From: Burski, Raymond [<mailto:RAYMOND.BURSKI@fpl.com>]
Sent: Tuesday, April 29, 2014 11:02 AM
To: Comar, Manny
Cc: Franzone, Steve
Subject: L-2014-111 Revised Response to NRC Request for Additional Information Letter No. 040 (eRAI 6006) - Standard Review Plan Section 02.05.04 – Stability of Subsurface Materials and Foundations - Email 2 of 2

Subject: FW: L-2014-111 Revised Response to NRC Request for Additional Information
Letter No. 040 (eRAI 6006) - Standard Review Plan Section 02.05.04 - Stability of Subsurface Materials
and Foundations - Email 2 of 2

In accordance with NUREG-0800, Standard Review Plan, Chapter 2.5.4, "Stability of Subsurface Materials and Foundations," please describe how shear and compressive wave velocity values are selected for design in Table 2.5.4- 209. Provide correlations for shear and compressive wave velocity between Table 2.5.4-209 and Table 2.5.4-215 to indicate what percentile is used for recommended values. Given the large deviations, especially on Key Largo and Fort Thompson formations (see Figures 2.5.4-218 and 2.5.4-19 and Table 2.5.4- 215), explain how the selected single value for each stratum statistically reflects the entire layer.

Figure 1 Plot of Recommended Shear Wave Velocity with Elevation

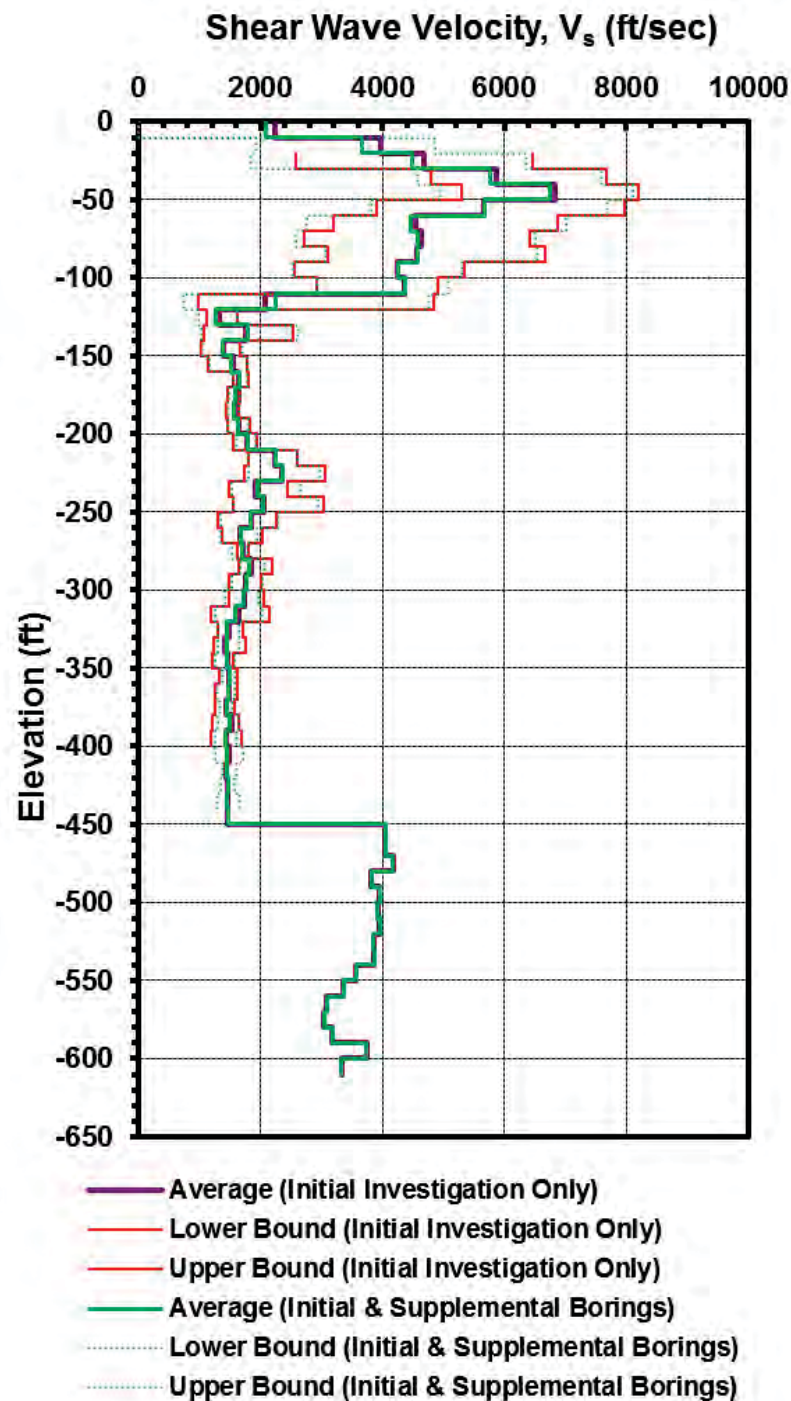
FSAR Figures 203 through 209 indicate one boring for each of the two Units extending to a depth of about 450'. Most other borings taken at the site extend to depths of only about 150'. Figure 2.5.4-220 presents information on shear wave velocity, including best estimate (BE) and upper/lower bound (UB/LB) values down to a depth of about 600'. In accordance with NUREG-0800, Standard Review Plan, Chapter 2.5.4, "Stability of Subsurface Materials and Foundations," please indicate how you estimated variations in shear wave velocity based on only two readings over the deeper portion of the profile.

Figure 1 and the revised FSAR Figure 2.5.4-220 presents the mean shear wave velocity (V_s) profile with upper and lower bounds (calculated as mean \pm standard deviation) as a function of depth for all 12 P-S Suspension velocity data sets.

Figure 2.5.4-220. Plot of Recommended Shear Wave Velocity with ~~Elevation~~Depth

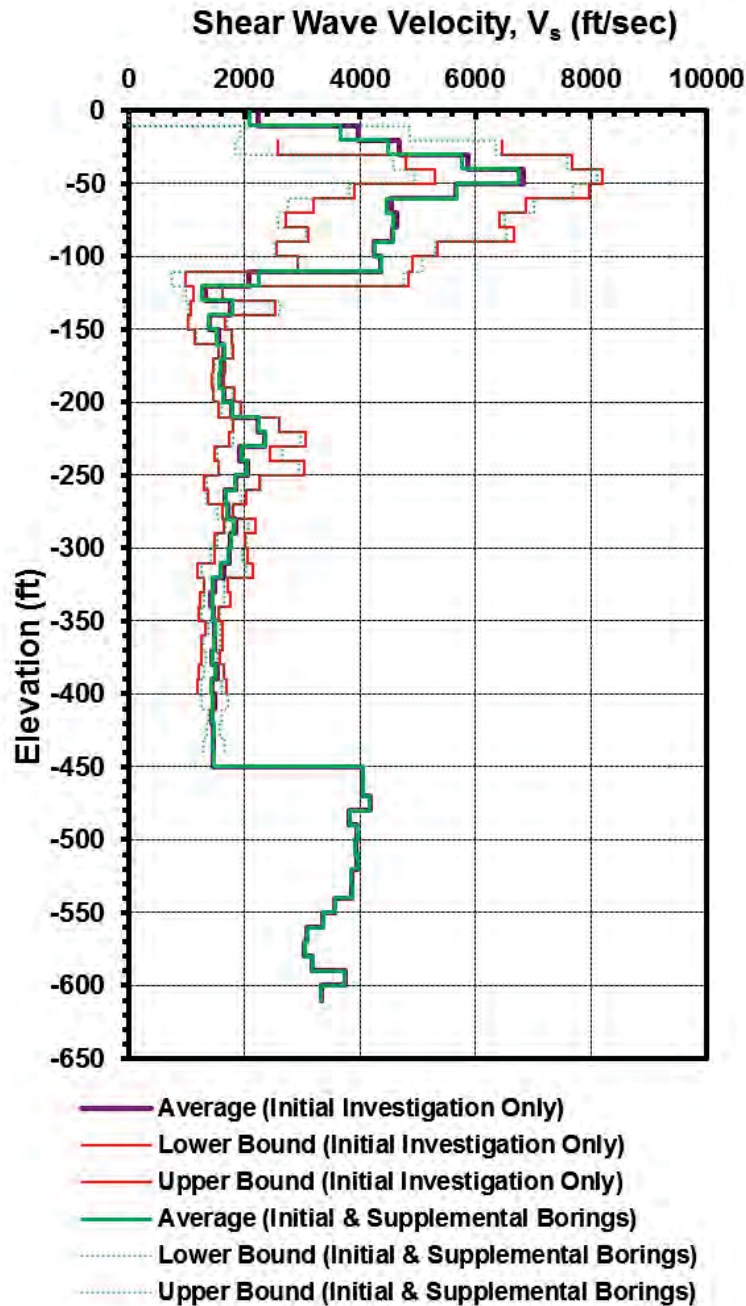
Figure 2.5.4-218 presents a plot of shear wave velocity measurements. Below the Fort Thompson formation, the soils are variously described as silty sands or silts and clays. However, the velocities do not show any change with depth. In accordance with NUREG-0800, Standard Review Plan, Chapter 2.5.4, "Stability of Subsurface Materials and Foundations," please indicate the data that was used to construct this figure and explain the uniformity in shear wave velocity below the Fort Thompson formation.

Suspension P-S velocity logging results summarized in Table 2.5.4-215 are used to develop the recommended V_s velocity profiles shown in Figure 2.5.4-220. The data collected at individual suspension P-S velocity logging borings and at individual seismic CPTs are sorted by stratum and averaged and presented in Table 2.5.4-209. ~~In this table, the measured V_c values in the saturated sand strata (Strata 5, 6, and 7) are adjusted to account for the high readings due to measuring the V_c of water. The average thickness and elevation of each stratum is also determined at each of the boring test locations and averaged. The V_s profiles given in Figure 2.5.4-218 plot measured shear wave versus depth, and indicate strata thicknesses and depths. Figure 2.5.4-220 illustrates the design V_s profile (average) for materials at the site from ground surface to approximately 450 600 feet depth from data measured at Units 6 and 7. Figure 2.5.4-220 includes the V_s data of one reading from 450–600 feet measured at Unit 7. As previously noted, Unit 7 V_s data are collected to a depth of approximately 600 feet, while at Unit 6 V_s data are collected to a depth of approximately 400 feet.~~

FSAR Figure 2.5.4-220 will be replaced with the following revised figure in a future revision:

Figure 2 Top Elevation of Key Largo Limestone

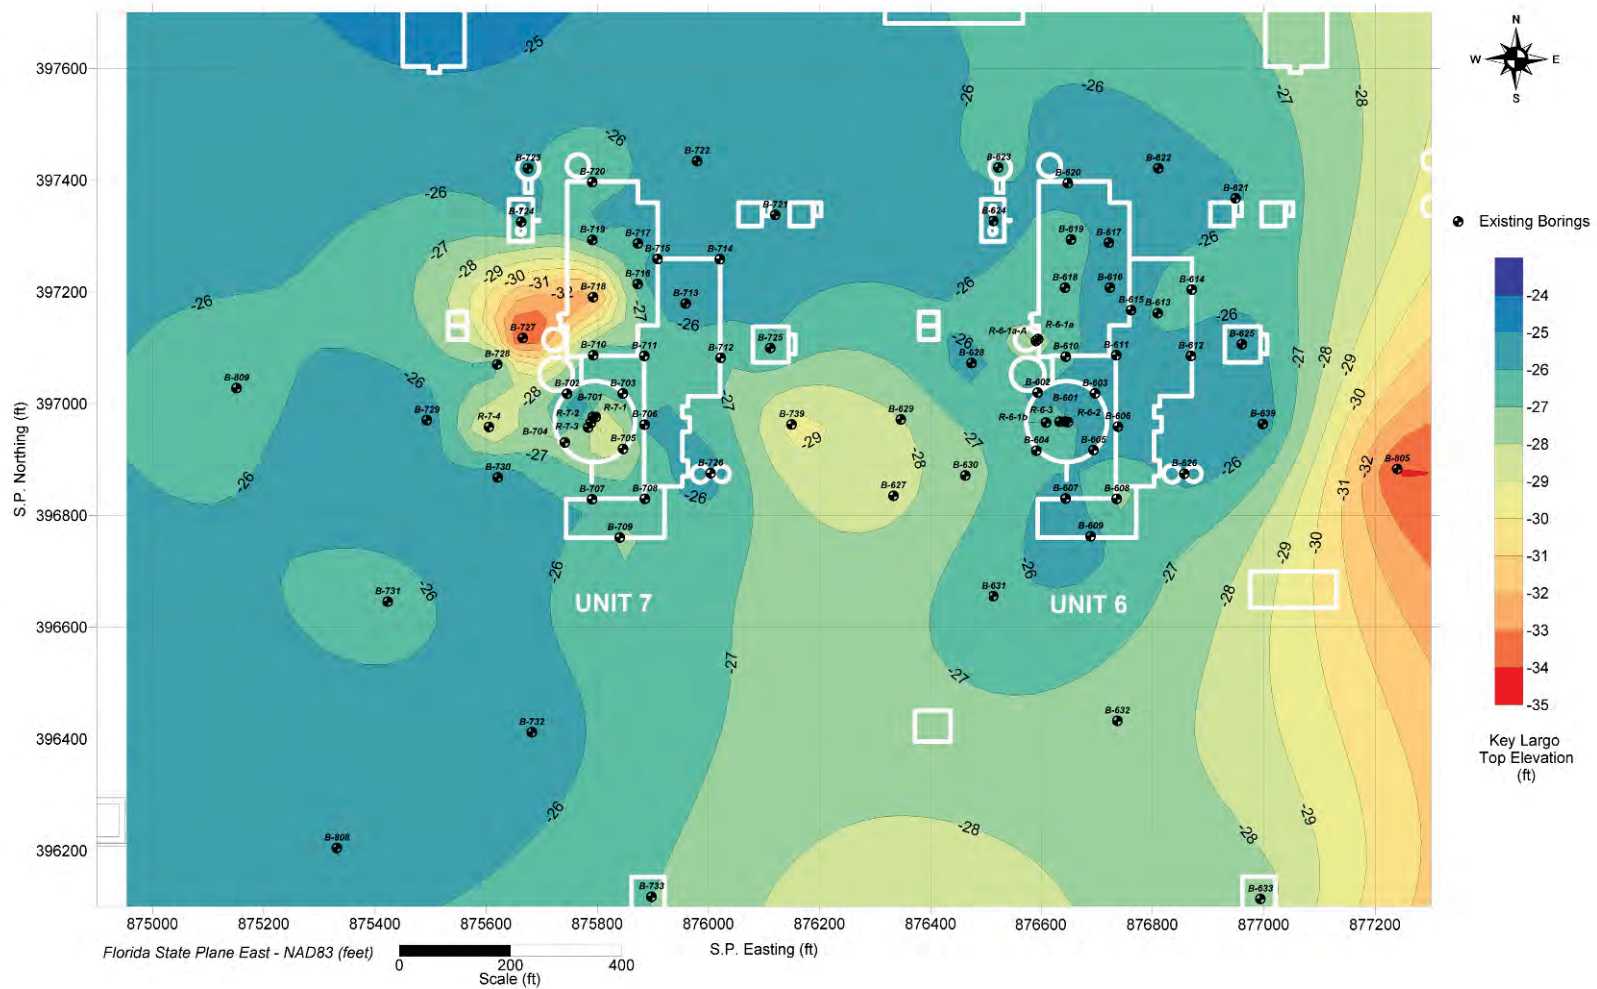
FSAR Figure 2.5.4-222 shows a general conceptual excavation cross-section. In accordance with NUREG-0800, Standard Review Plan, Chapter 2.5.4, "Stability of Subsurface Materials and Foundations," please describe the procedures that will be followed during site excavation and construction activity to ensure that the appropriate strata for the proposed foundation locations are confirmed through objective measures and the exposed foundation laying surface is uniform. Also, please provide the vertical and horizontal extent of all seismic categories I excavations, fills, and slopes, including the locations and limits of excavations, fills, and backfills on plot plans and geologic sections and profiles.

In addition, surveying during excavation will ensure the proper depth is reached and excavation into the Key Largo is accomplished across the foundation site. Based on all borings in the initial and supplemental site investigations, the top of the Key Largo Limestone is never encountered at or below El. -35 feet within the power block boundary. In a few borings, the top of the Key Largo approaches El. -35 feet, but these locations are not under either NI and are therefore not foundation bearing materials. Figure 2 illustrates a contour plot of the elevation of the Miami and Key Largo interface.

Figure 2.5.4-232 Shear Modulus Degradation for Key Largo Based on RCTS Testing

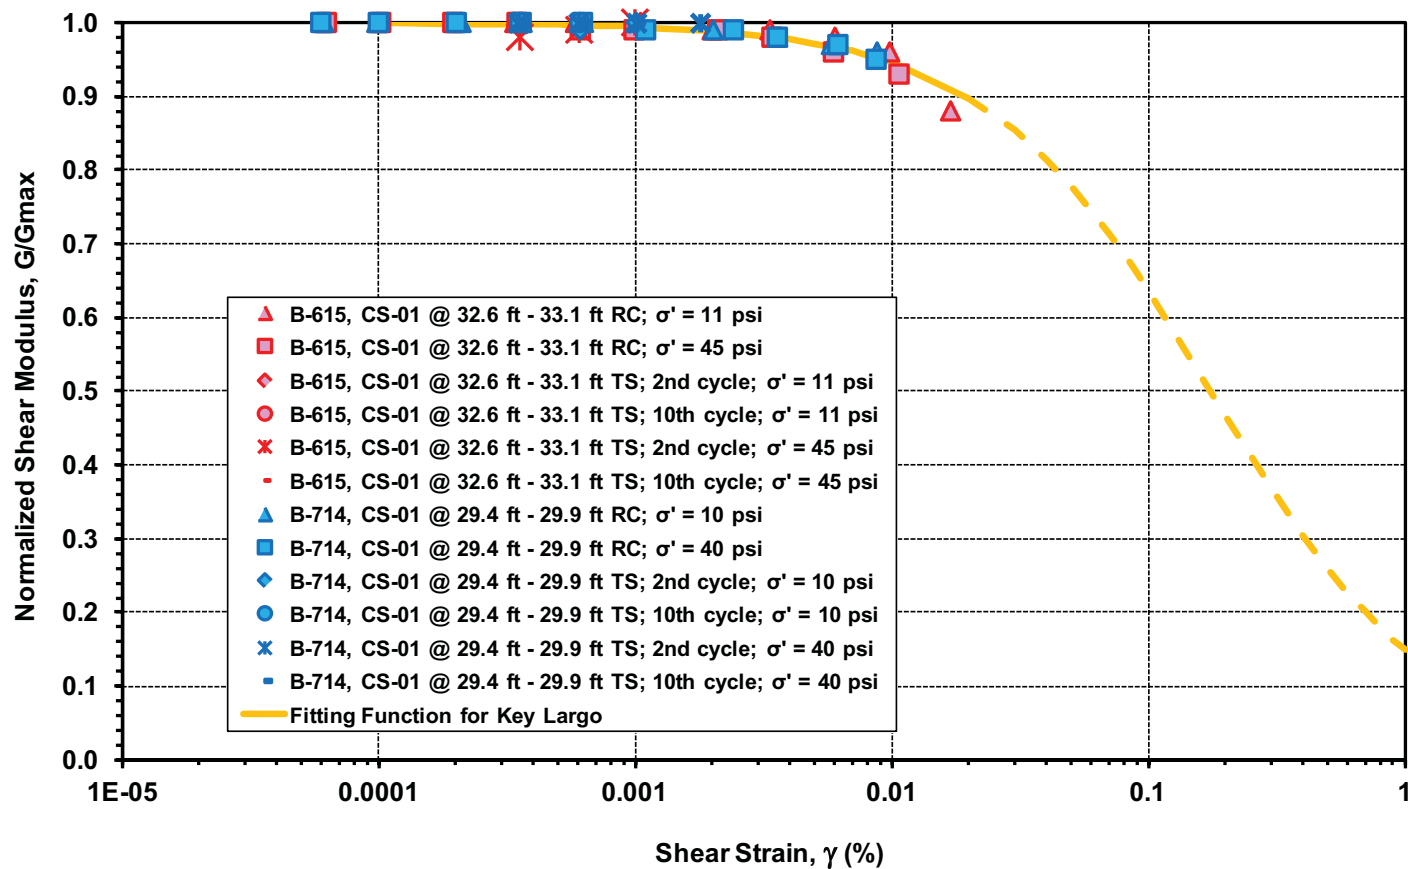
Section 2.5.4.7.3.3 "Shear modulus and Damping for Rock", indicates that the damping for rock is taken as 1%. The damping shown in Figure 2.5.2-249, which describes the soil properties used to develop the GMRS, indicates that a damping value of 0.5% was used in the analyses. In accordance with NUREG- 0800, Standard Review Plan, Chapter 2.5.4, "Stability of Subsurface Materials and Foundations," please provide clarification as to the actual level of damping used in the analyses and provide a basis for its selection considering the large variability in RQD shown in Figure 2.5.4-215.

The modulus degradation curves (plots of G/G_{\max} versus shear strain) from actual RCTS tests are presented on Figure 2.5.4-232 **for the Key Largo Formation, Figure 2.5.4-246 for the Fort Thompson Formation, Figure 2.5.4-247 for natural soils less than 150 feet deep, and Figure 2.5.4-248 for natural soils greater than 150 feet deep**. Figure 2.5.4-233 shows the selected values of G/G_{\max} versus shear strain for the ~~two~~^{five} strata tested in the power block in addition to the other site strata addressed in this evaluation. The selected G/G_{\max} versus strain values for each stratum are also presented in Table 2.5.4-216.

FSAR Figure 2.5.4-232 will be replaced with the following figure in a future revision:

Figure 2.5.4-238 Factor of Safety against Liquefaction Based on CPT Values

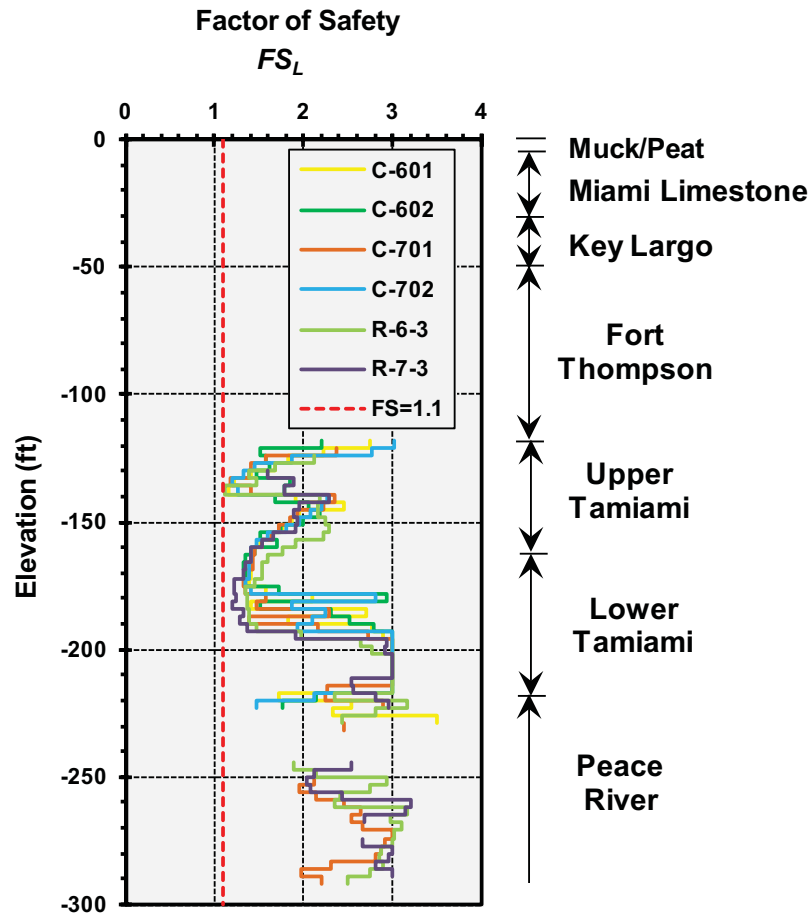
~~Table 2.5.4-218 is a summary of the results of the calculations. The native soils that indicate the lowest FOS values are those in the upper Tamiami Formation. However, the FOS values calculated indicate adequate resistance to liquefaction based on published criteria ($FOS > 1.25$). The FOS as a function of elevation for the CPT-based calculations is presented in Figure 2.5.4-238. As described above, even if liquefaction occurs, the~~

CPT testing at the Turkey Point Units 6 & 7 site includes the measurement of commonly measured cone parameters (tip resistance and sleeve friction). The evaluation of liquefaction based on commonly measured parameters is discussed herein. The equivalent clean-sand $CRR_{7.5}$ value, based on CPT measurements, is calculated following recommendations found in Reference 219, based on normalized clean sand cone penetration resistance (q_{c1Ncs}) and other parameters such as the soil behavior type index, I_c . Cone tip resistance values from CPT soundings are shown in Figure 2.5.4-214 for the power block area. The deepest CPT soundings (C-701, R-6-3 and R-7-3) penetrate 289 feet below the ground surface, encountering refusal at that depth. Tip resistance measurements are made at 2 centimeter (cm) intervals (0.79 inches) during the initial investigation (Reference 257) and at 5 cm intervals (2 inches) during the supplemental investigation (Reference 290). The results showing FOS against liquefaction using the CPT data are provided in Figure 2.5.4-238 for the power block area. The value of FOS is consistently higher than 1.1 across the full depth of testing at the site. Based on CPT data, there is no potential for liquefaction for the Turkey Point Unit 6 & 7 power block area.

Figure 2.5.4-238 will be replaced in a future revision as follows:
